PERMIT REPORT

Re: Metropolitan Council; Permit 18-670: Emergency Relief Structure 04 and Sanitary Tunnel 344 – Minnehaha Parkway, Minneapolis

1
GC16
TEMPORARY BRIDGE - ENLARGED PLAN
1" = 10'

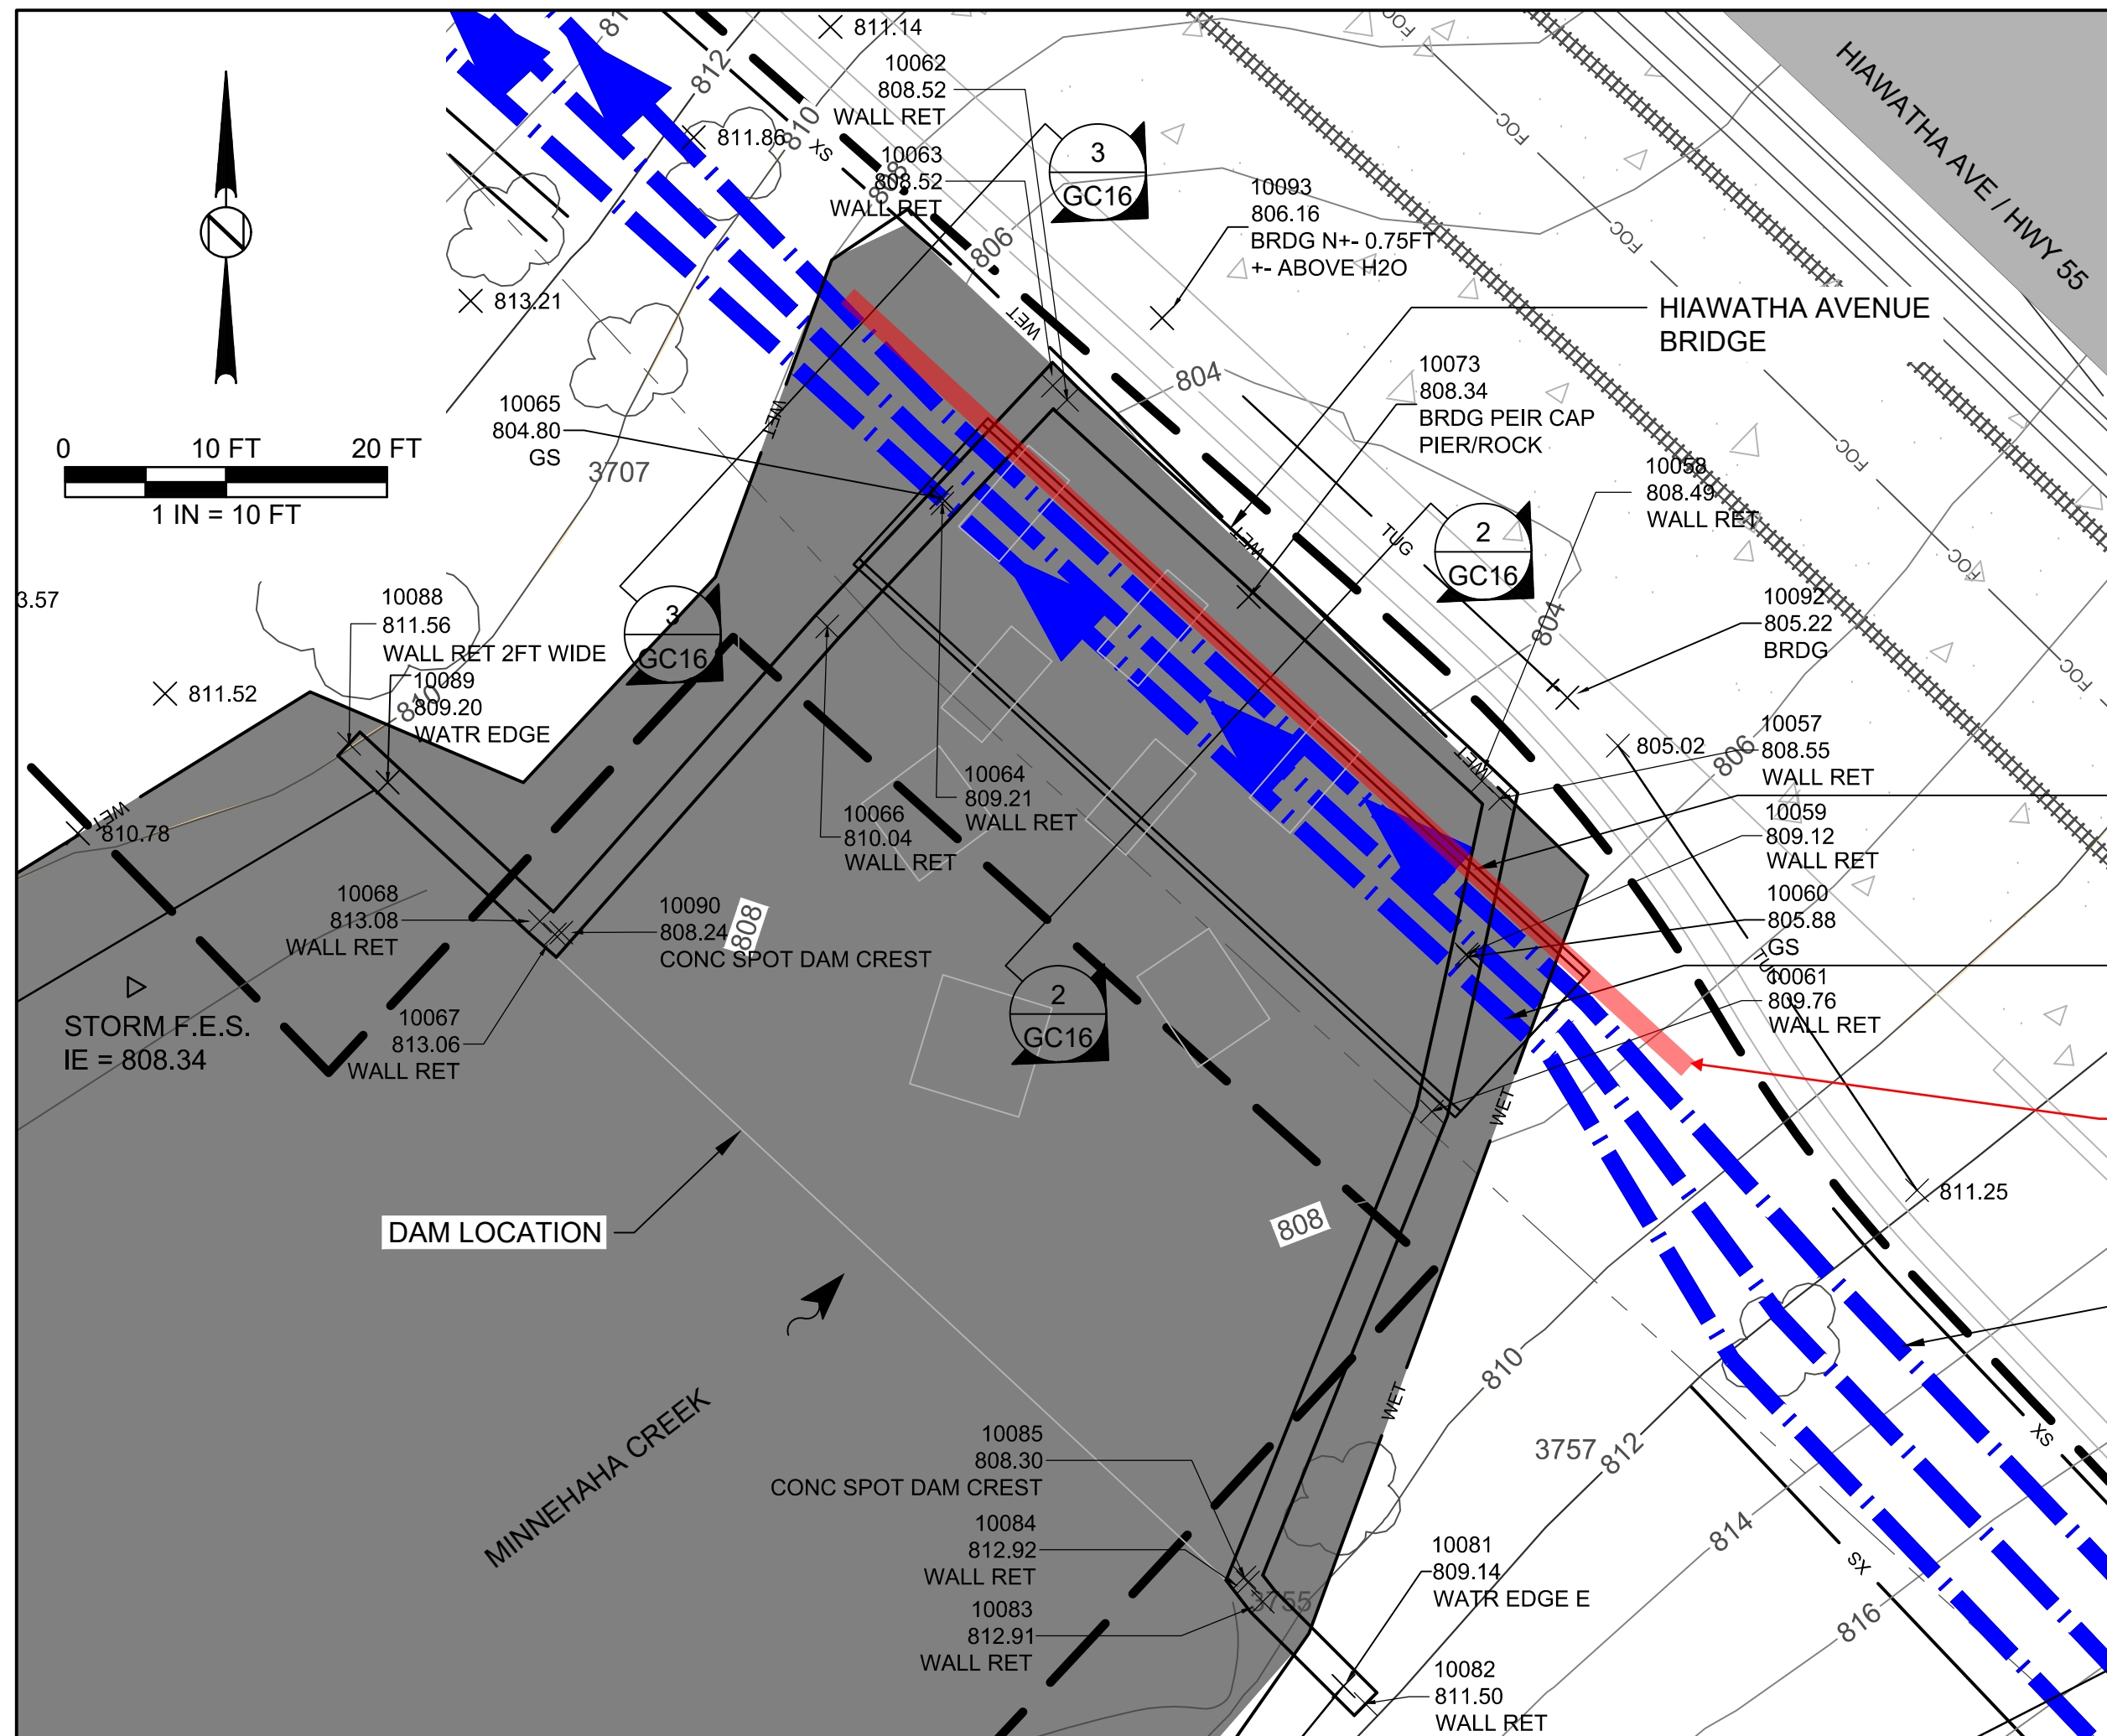
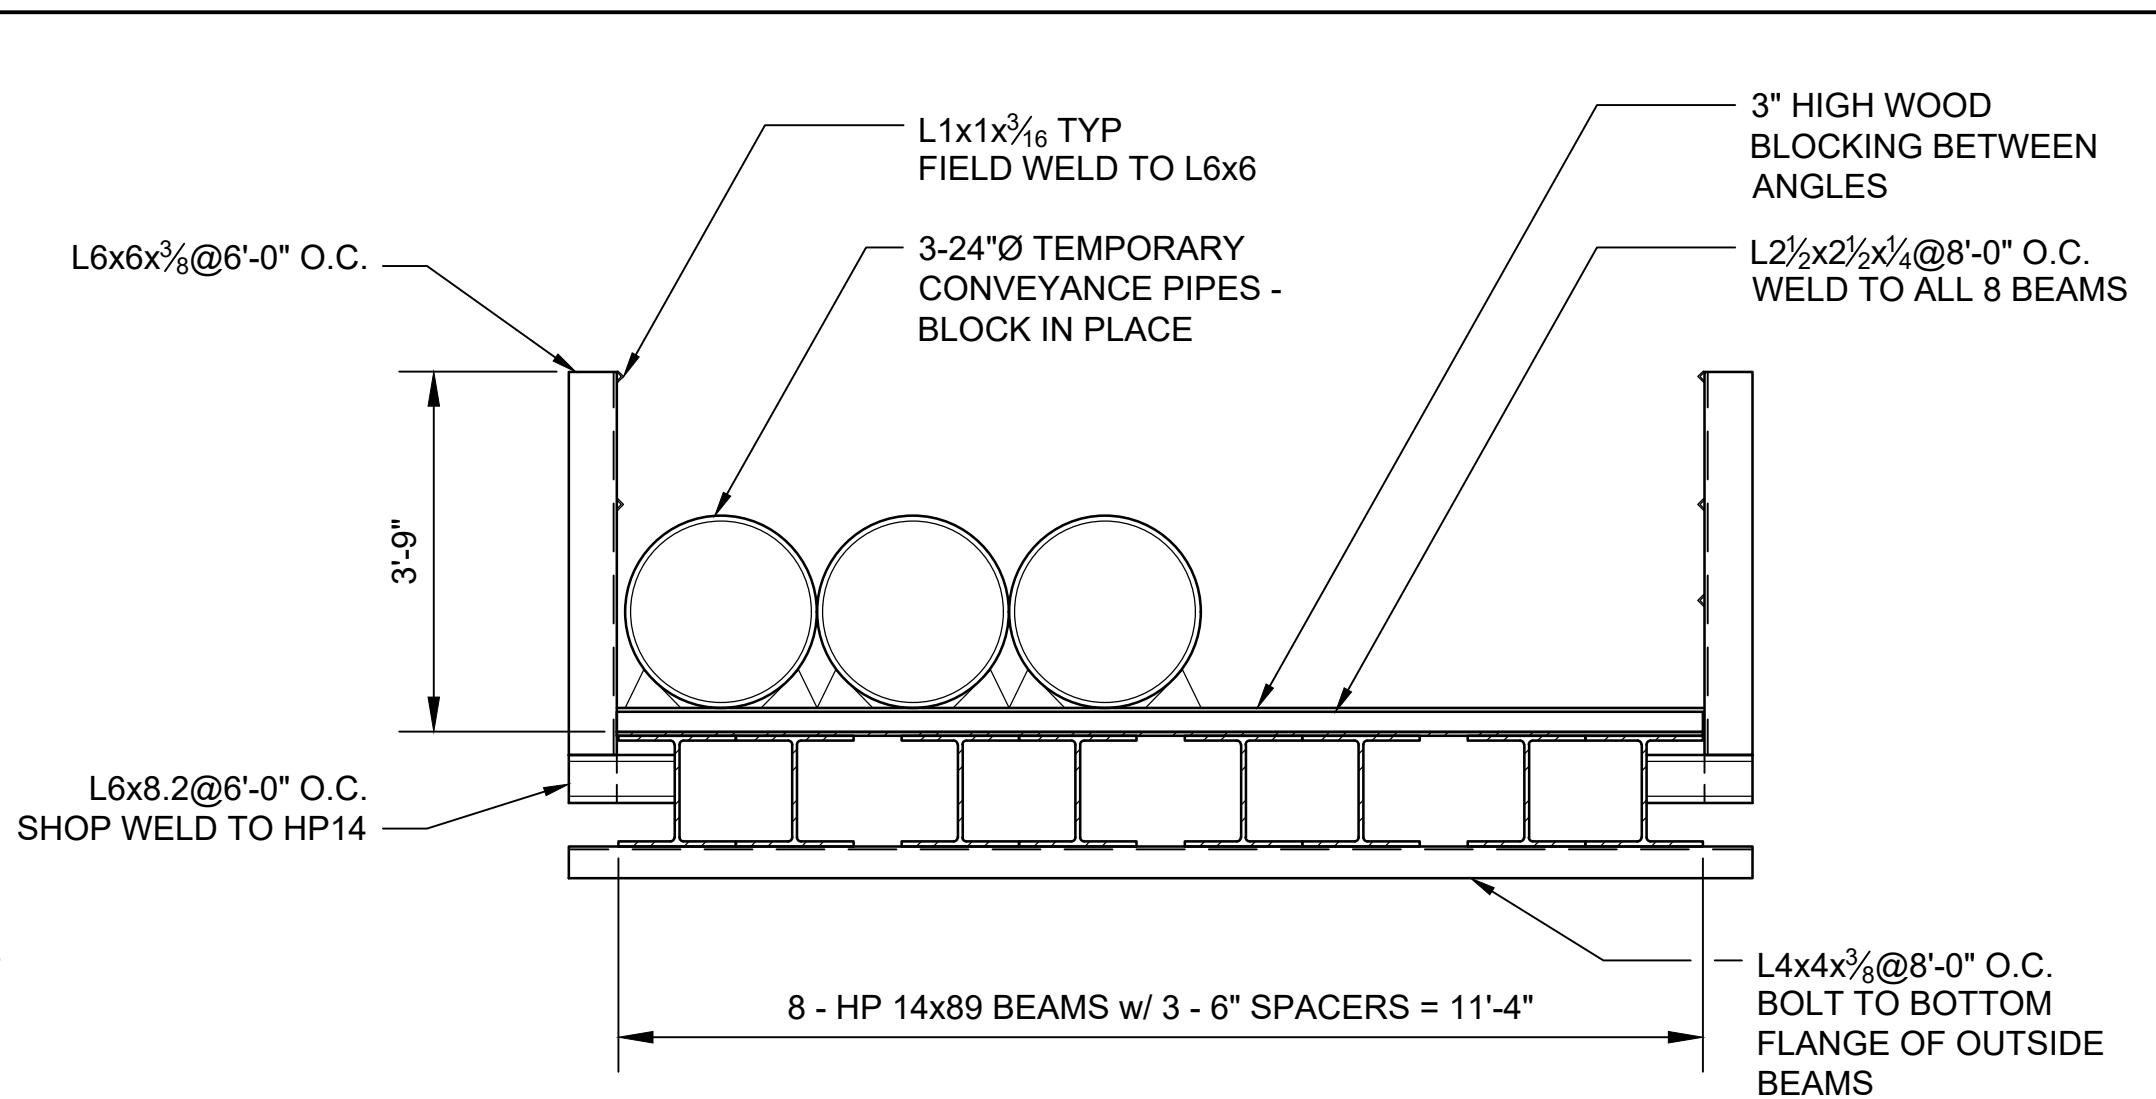
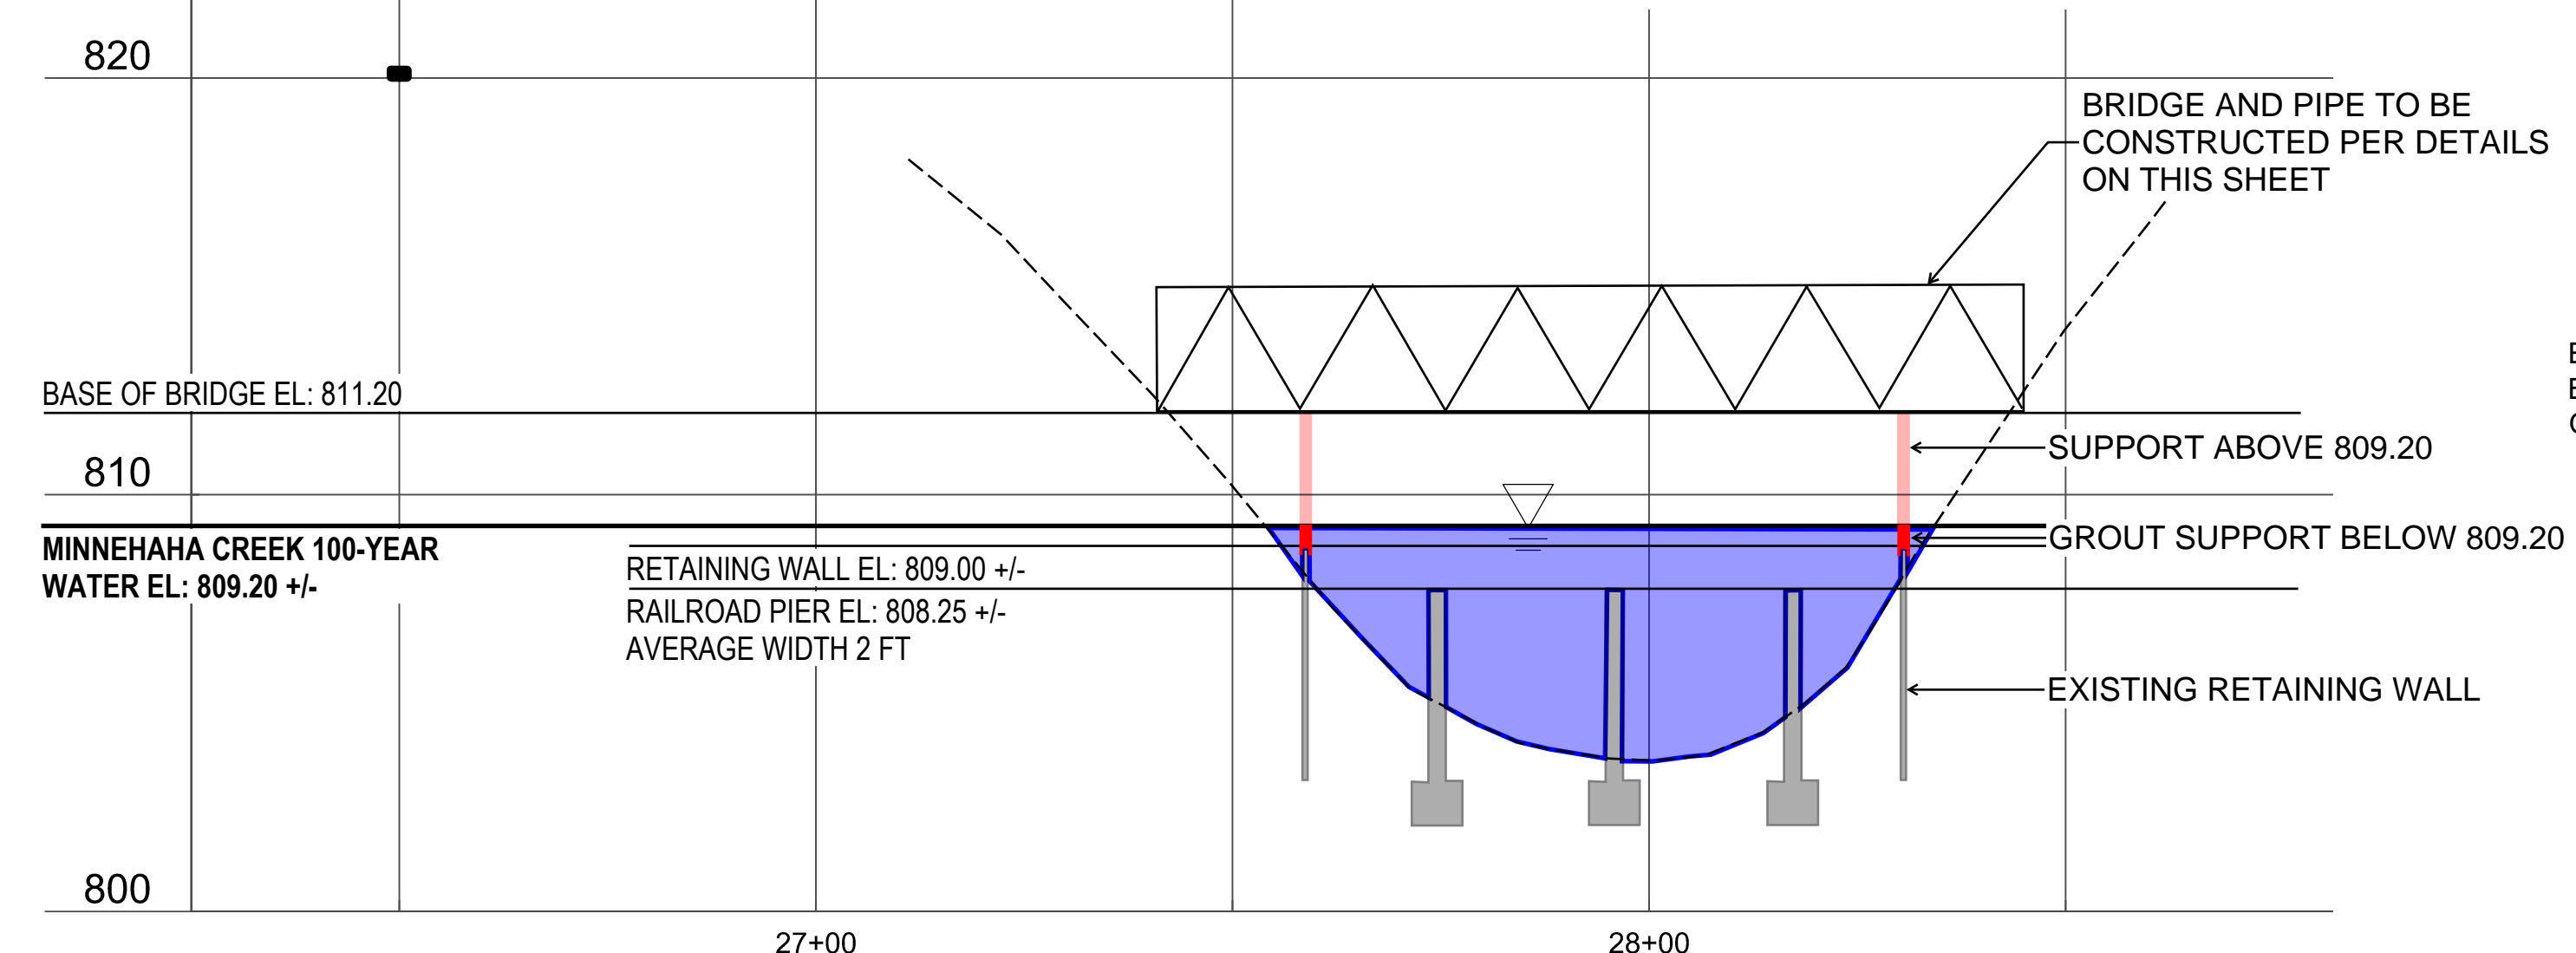
Section 3(b) of the rule requires no increase in the 100-year flood elevation of a watercourse. The bridge abutments make up 0.5% of the cross-sectional area of the channel and the temporary conveyance under the Minnehaha Parkway bridge make up 0.2% of the cross sectional area of the channel. The modification is smaller than the sensitivity of hydraulic models, therefore the applicant has determined that no impact will be made on hydraulic capacity. The District

modification is smaller than the sensitivity of hydraulic models, therefore the applicant has determined that no impact will be made on hydraulic capacity. The District Engineer concurs with the analysis and that hydraulic capacity is maintained.
